A G E N D A

Architectural Review Board

February 24, 2015

3144 Montezuma Road

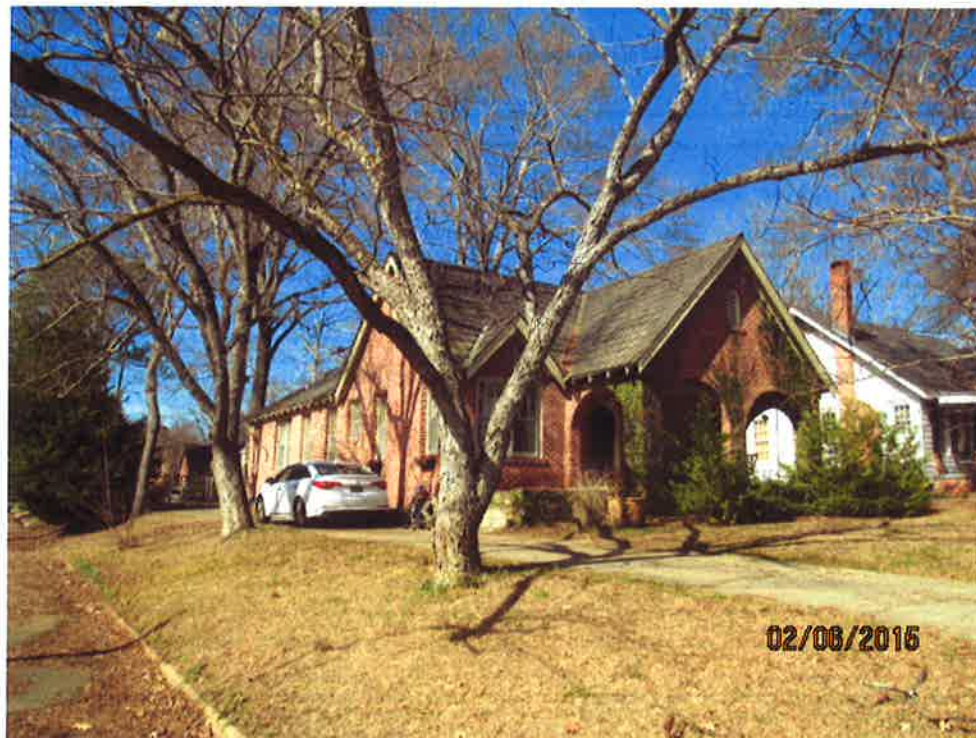
REMARKS: The petitioner is requesting permission to change the existing, rectangular asbestos roof shingle to an architectural tab shingle. The color to be installed is "slate". According to the owner, there are additional layers of shingles under the current roof, which would indicate it is not the original material, but is likely a historic addition.

- The Board needs to determine if the rectangular shingle is a character defining feature of the house.
- The Board approved the replacement of a similar roof with an architectural tab shingle on a wood sided house in Cloverdale in November, 2014.

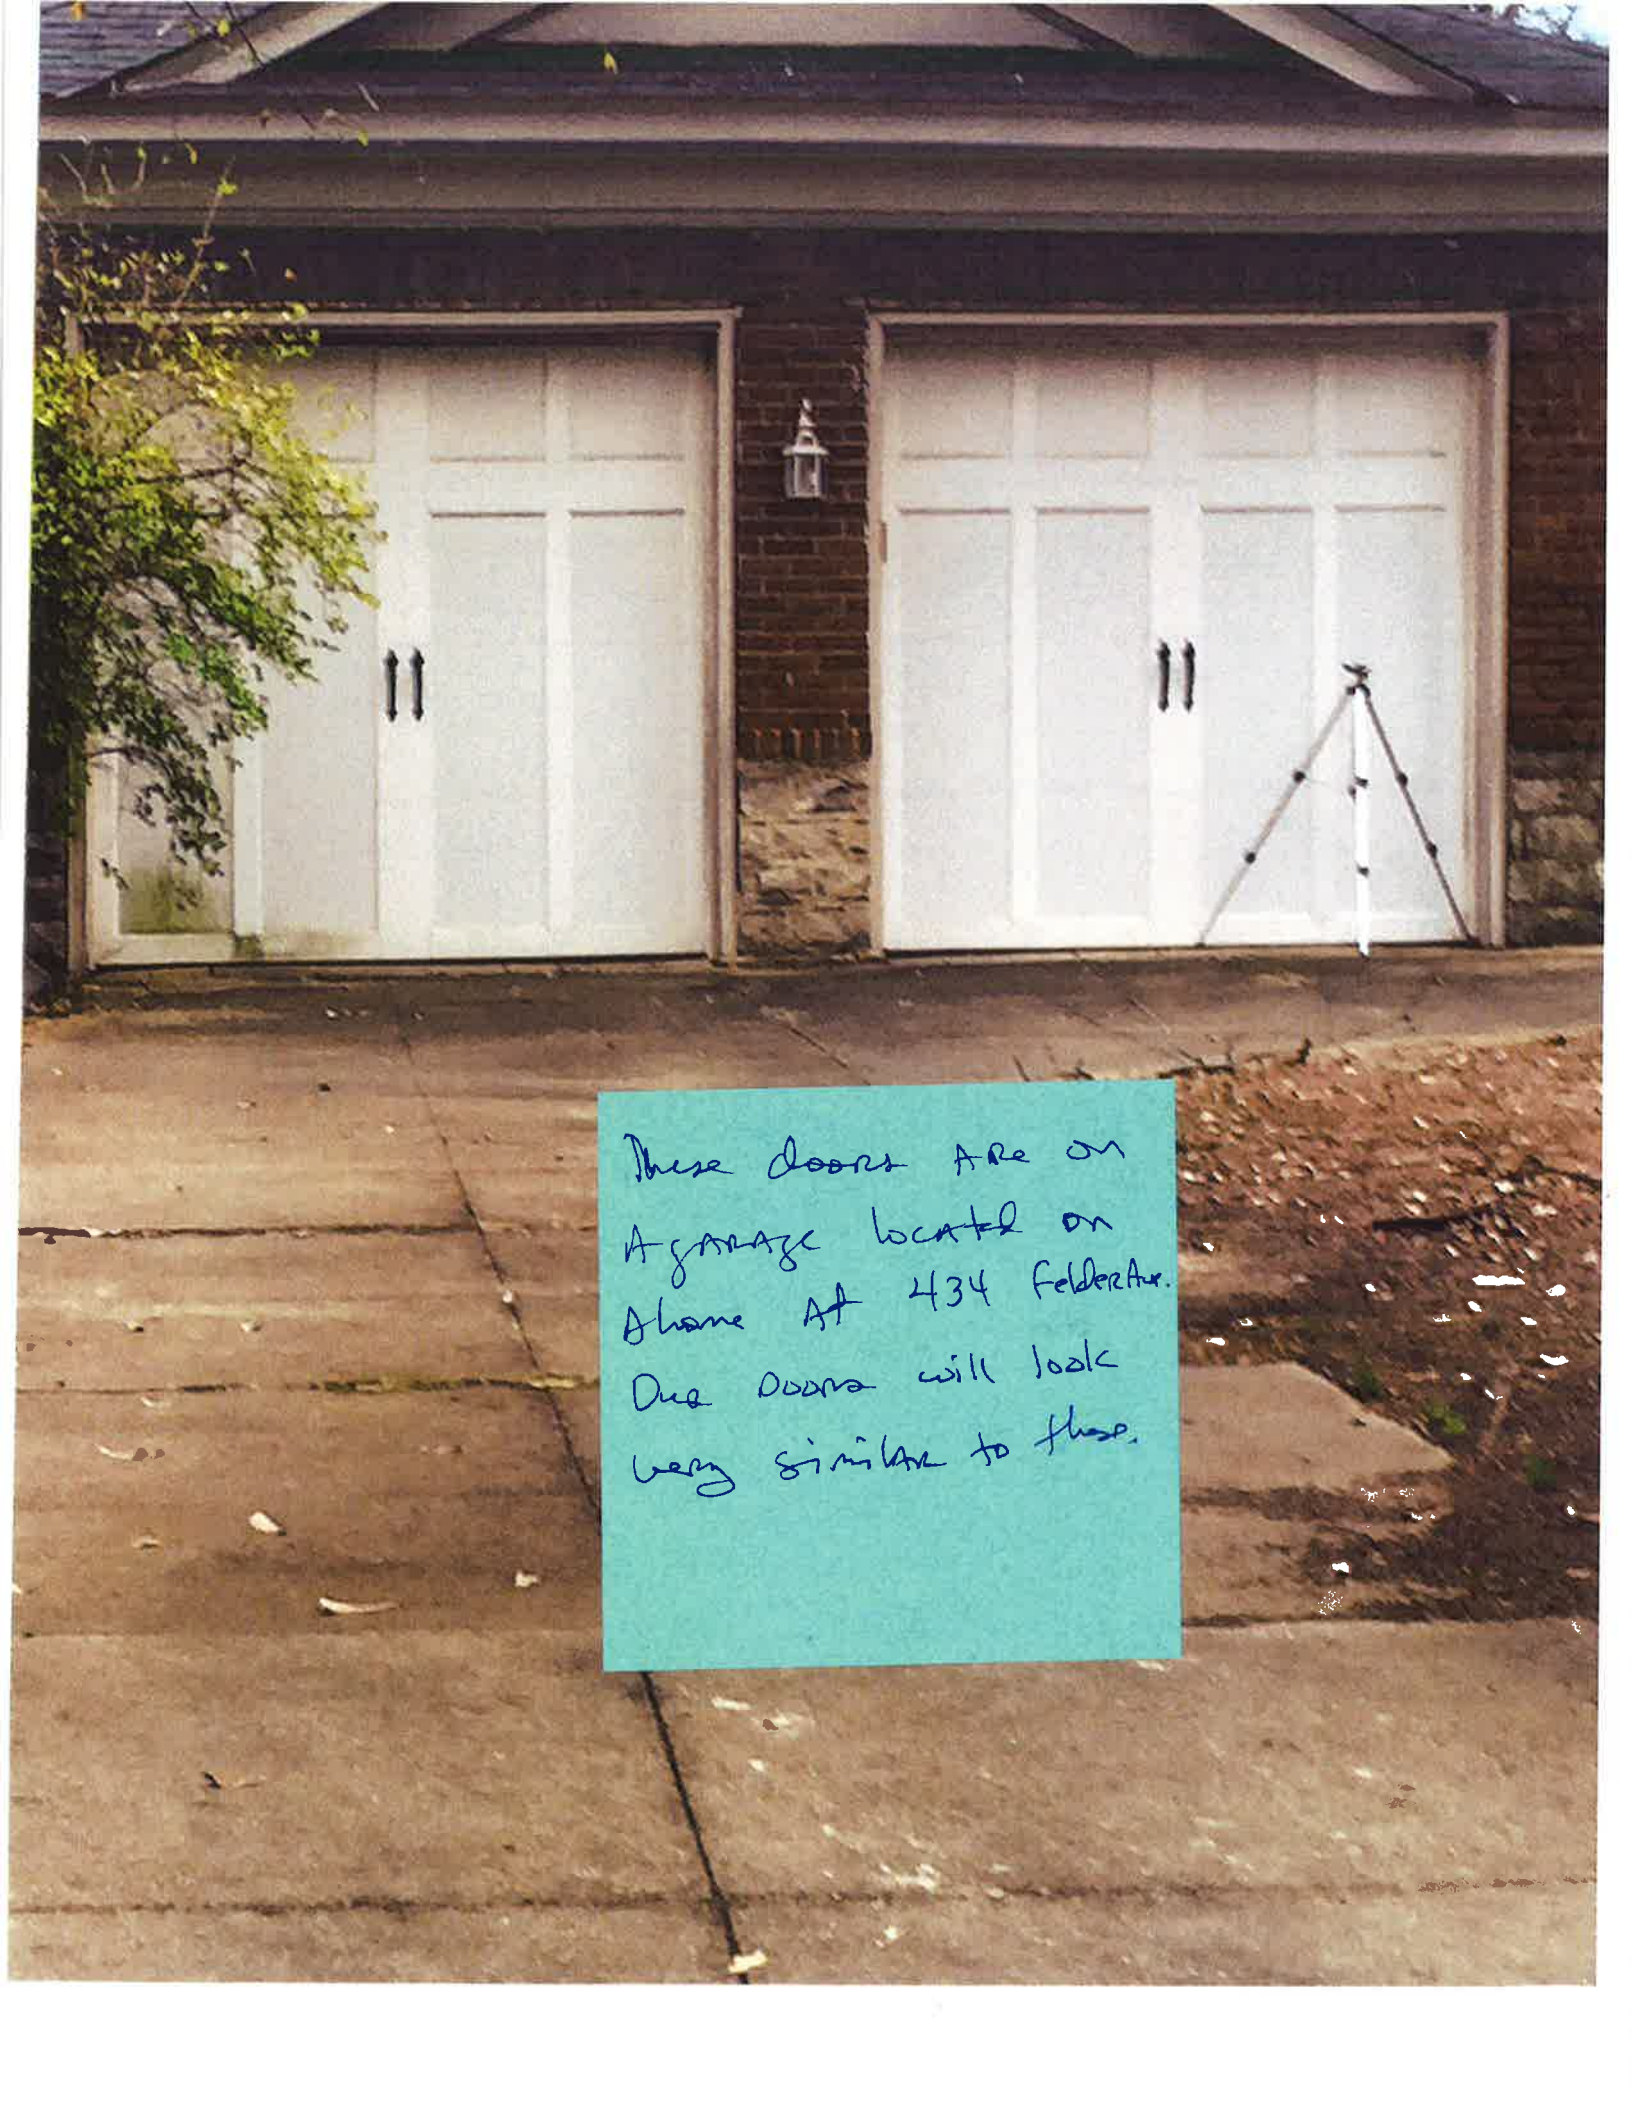
REMARKS: The petitioner is requesting permission to remove the existing garage doors with windows (they are painted over) with solid wood garage doors as illustrated. All paint colors will match the current doors, which match the house colors.

- The change from a door with lites to a door with no lites is what triggered the necessity of review.
- The proposed doors are a similar style to the existing.

Photo 8

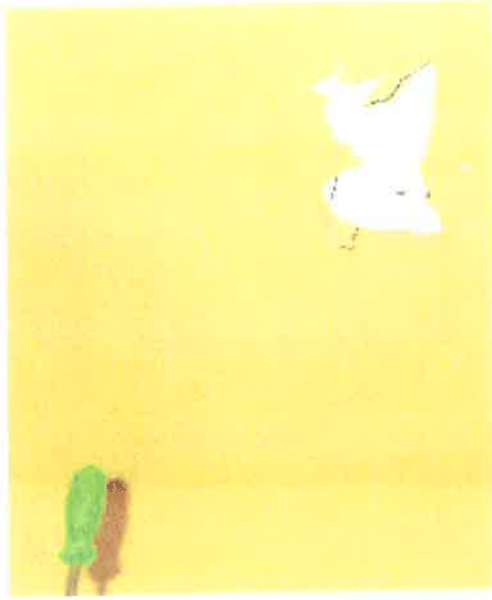
**Ceiling damage to up/
front/Hall ceiling ; remedy
roof leaks then repair ceilings**

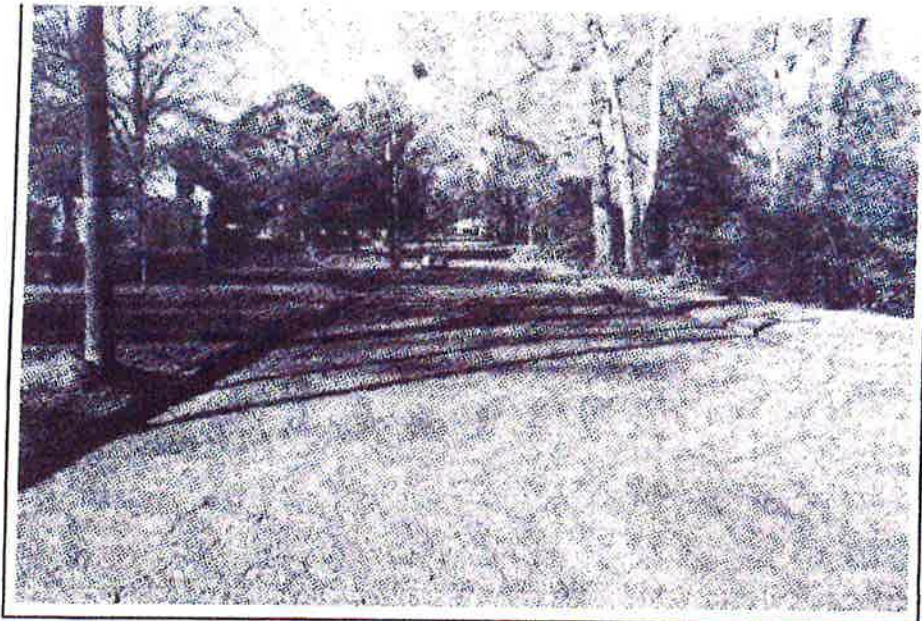
PAINT CHIMNEY & SIDING
CHANGE 3 TAB SHINGLES
TO ARCHITECTURAL

SIDING COLOR PER
COLOR CHART
TRIM TO REMAIN

WHITE
REPLACE FRONT
WINDOWS W/
MARVIN BRAND
UPPER SASH W/(3)
VERTICAL GRIDS

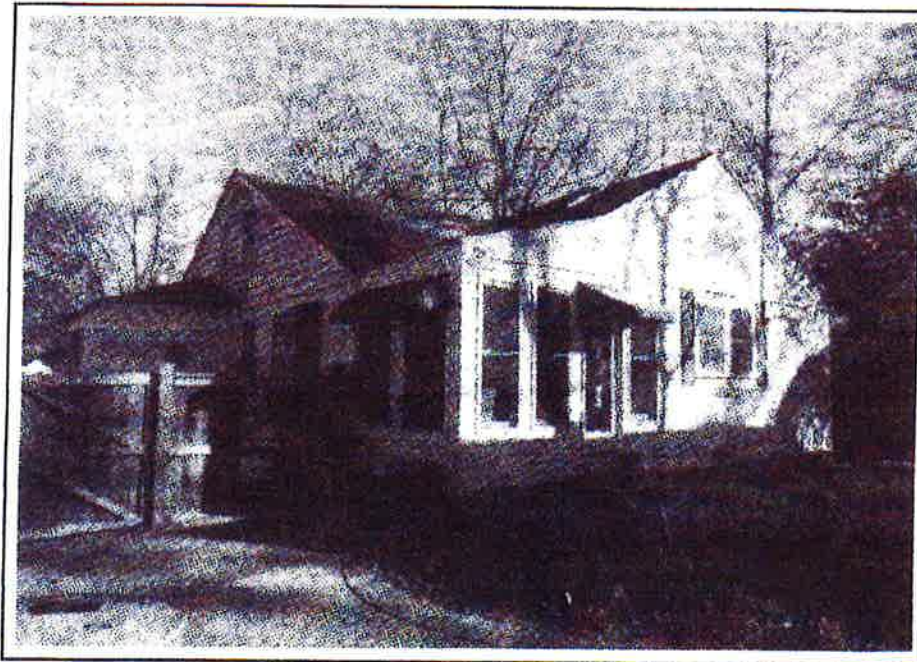
Missing Handrails at steps and missing
guardrailing with pickets at porch

CHANGE COLUMNS
TO 8" ϕ ROUND
